**Sent:** 16/08/2021 2:02:34 PM  
**Subject:** Submission on DA2021/1200  
**Attachments:** Objection Lodged.docx;

**1 Kanimbla Crescent Bilgola Plateau**  
**Application Number: DA2021/1200**

SUBMISSION

Current West View to bushland from Living Room, Master Bedroom and Front Balcony where proposed Southern Extension is to be Situated.

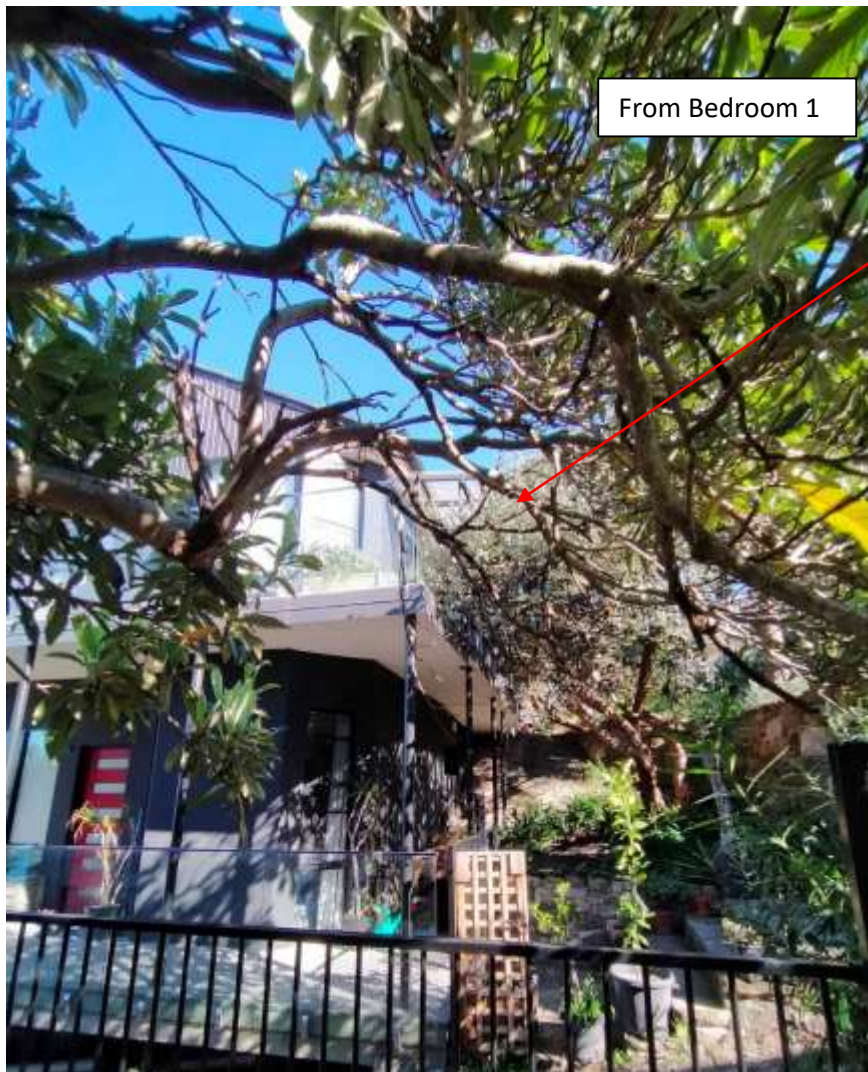
1 The bulk and substantial height of the Southerly extension will completely block our current West view over pristine bushland and the skyline from our Living Room, Balcony and Master Bedroom-see photo. It will not preserve nor enhance the bushland character.

The alignment of buildings clearly shows that all are aligned to not interfere with individual vistas and privacy.
